SERVICE BULLETIN # 00131

SUBJECT: Potential "Lock-Up" With NovRAM Devices in GII Version 2 Control Boards

MODELS: GIIv2 or GIII Venders Built Prior to Production Run #1344

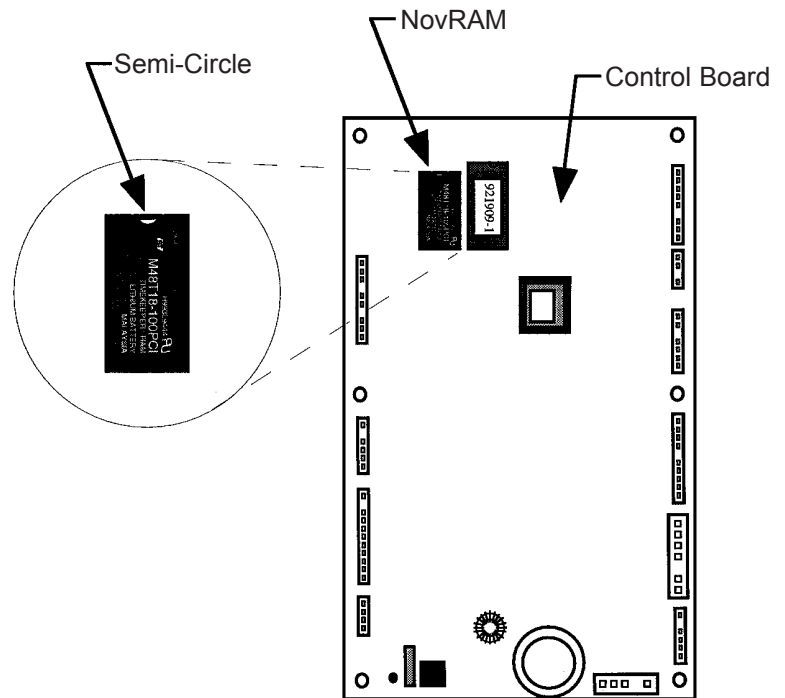
The NovRAM device with "DALLAS" on them could potentially lock, denying any access and causing the L.E.D. display to register

1. Remove power from vender by unplugging vender's main power cord from the AC voltage power source (wall outlet).
2. Access the controller board by removing the two screws that secure the control board's cover.
3. Using a small screwdriver, remove the NovRAM device from it's socket. The NovRAM is the upper left most chip on the controller board as it is mounted in the vender (see illustration).

NOTE: Pay close attention to the direction in which the NovRam is installed and install the new one in the same direction. (Match the semi-circle on one end of the NovRam to the one on the controller board NovRAM socket. see illustration)

4. With the new NovRAM installed, reapply power to the controller board and note that the L.E.D. lights should display the proper greeting.

NOTE: It is necessary that the controller board be reconfigured to the same setting that it had been originally. ie. space to sales, vend price, column depth. Refer to set up instruction sheets.
